ITD District 3 Improvements

Prebid RFI Log

Last Updated: 5/17/2024

ITD D3 Improvements and Addition

DISTRICT #3 - SITE DATA PLAN
 SCALE: 1"=40'-0"

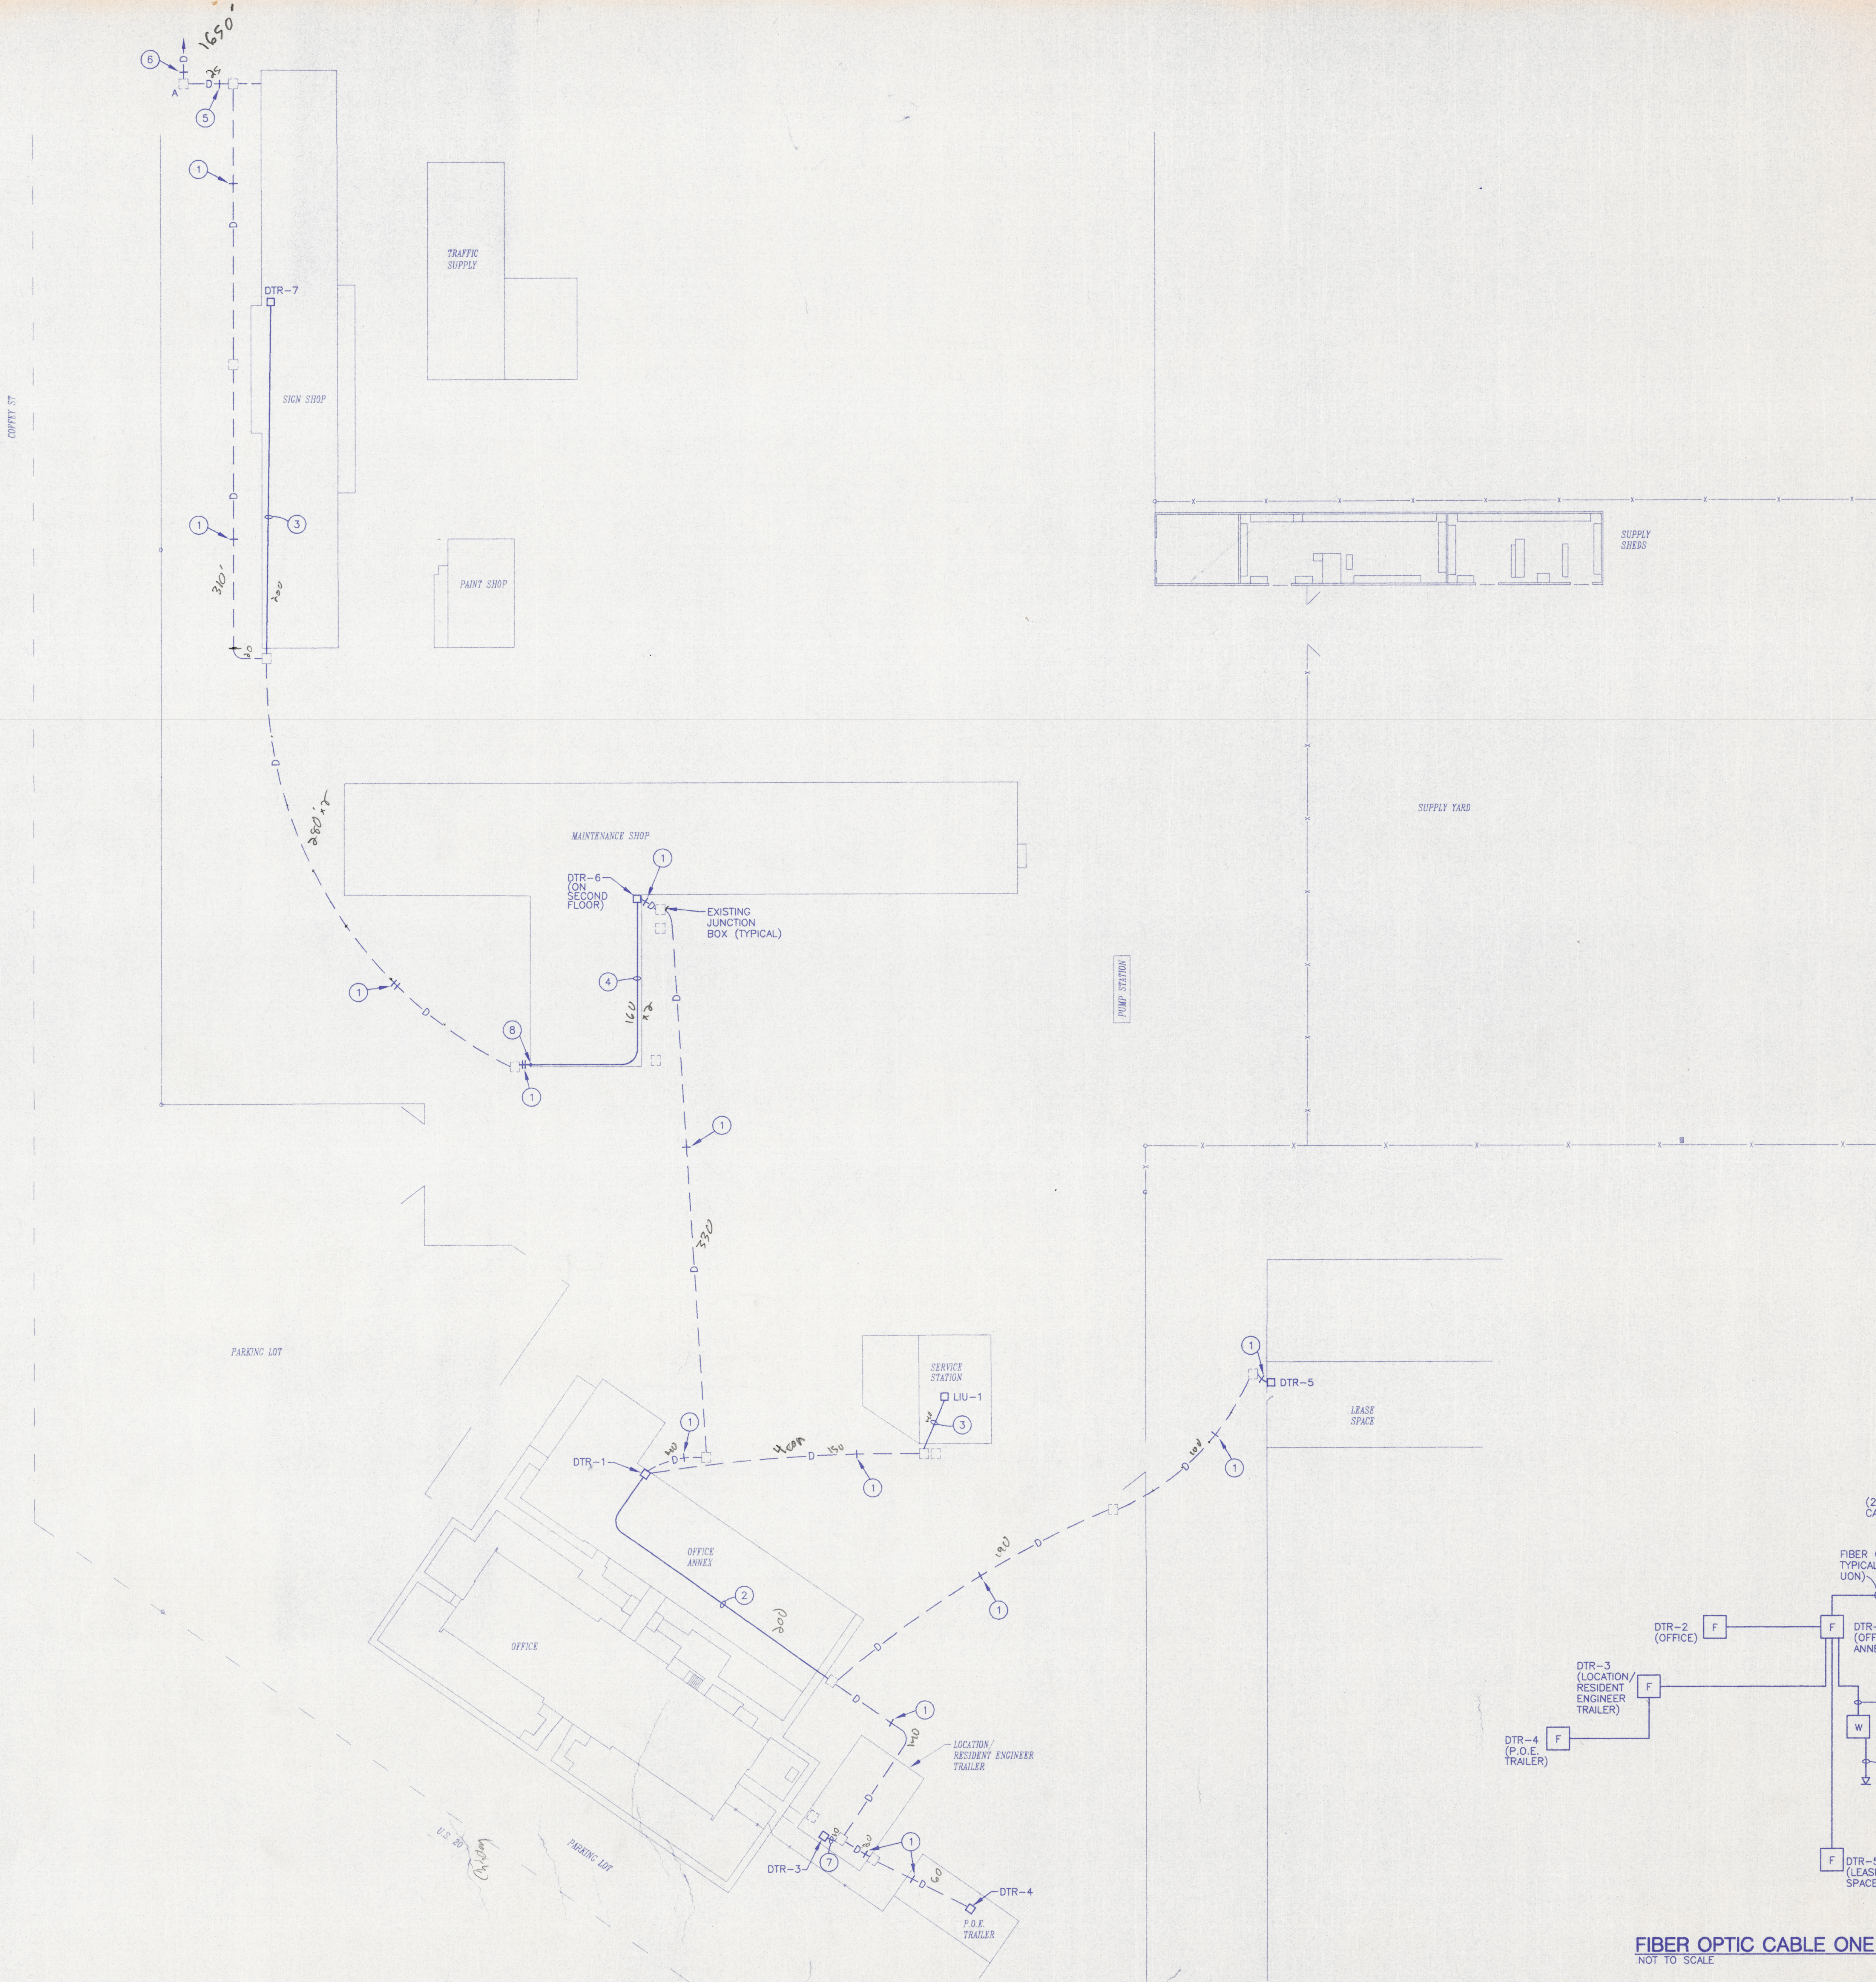
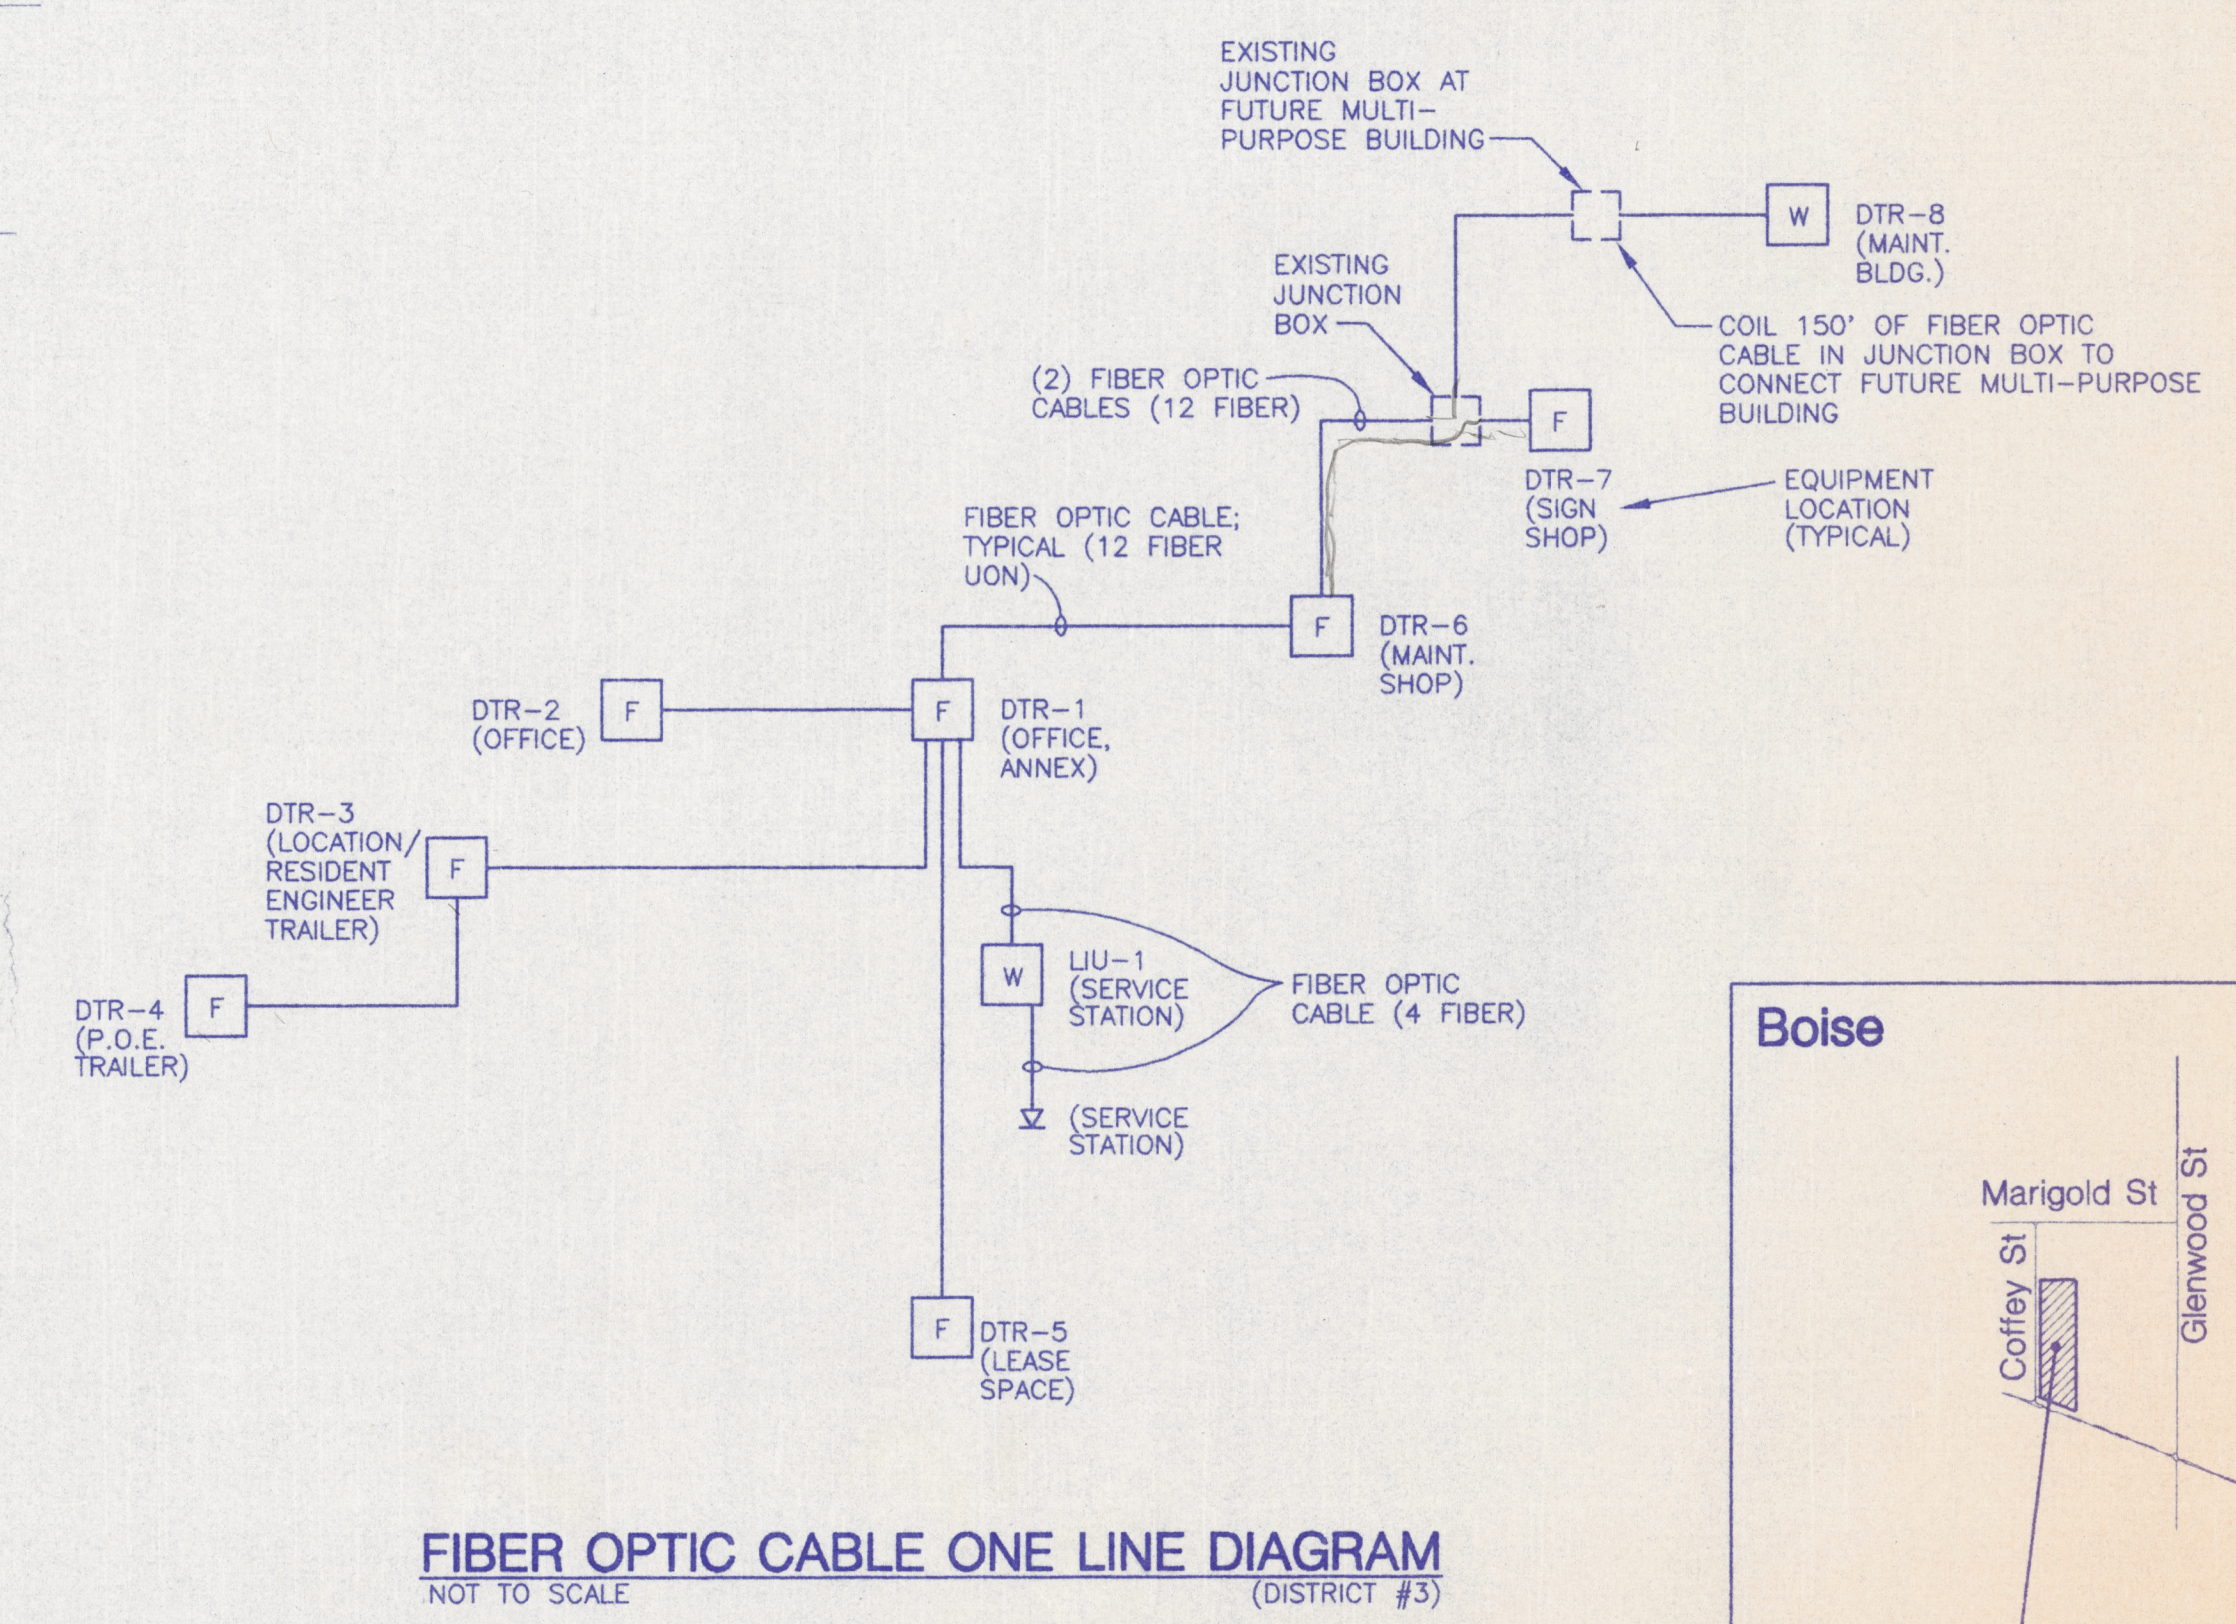
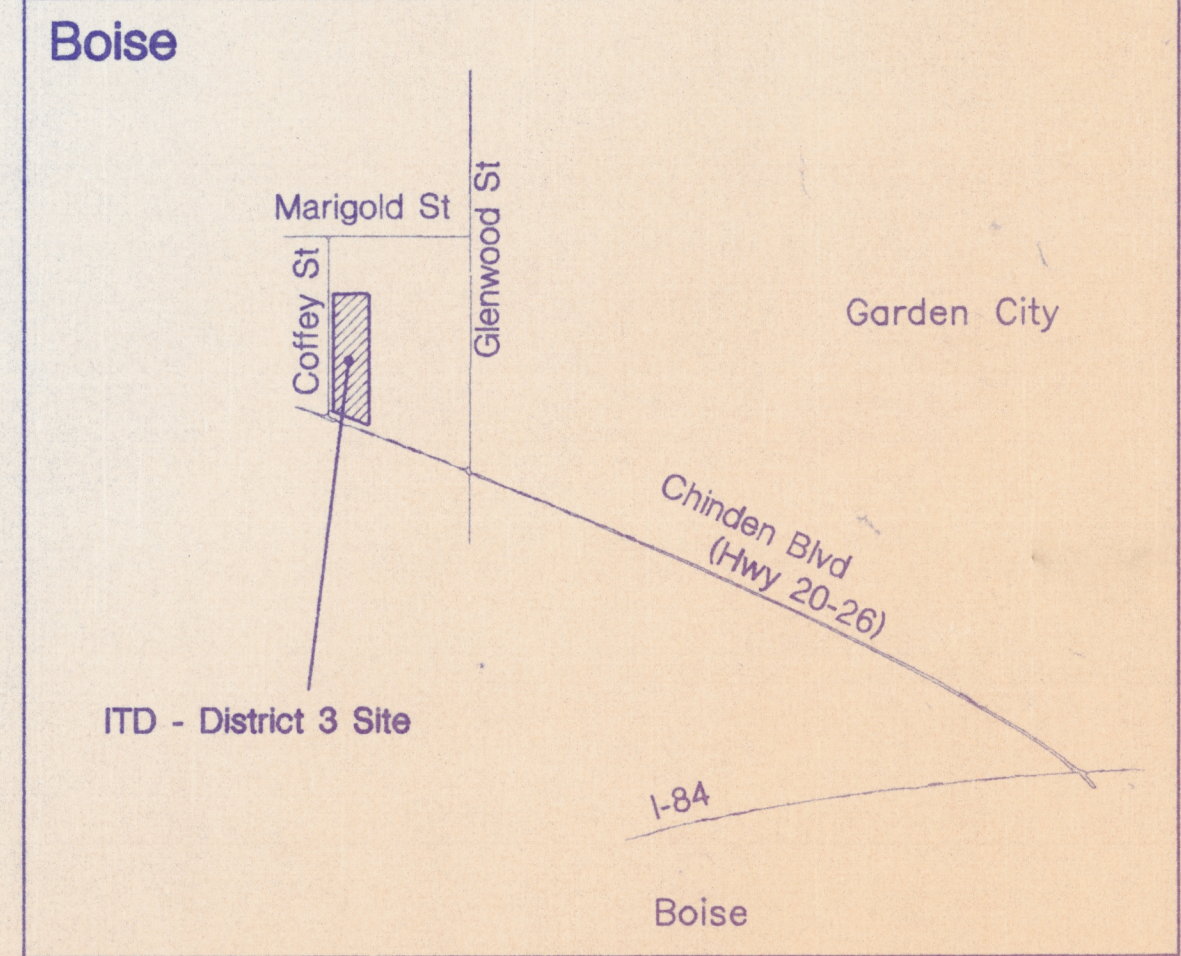
**PER OWNER, THIS BOX AND
CABLING IS OUT OF SERVICE -
CAN BE REMOVED AND
ABANDONED.**
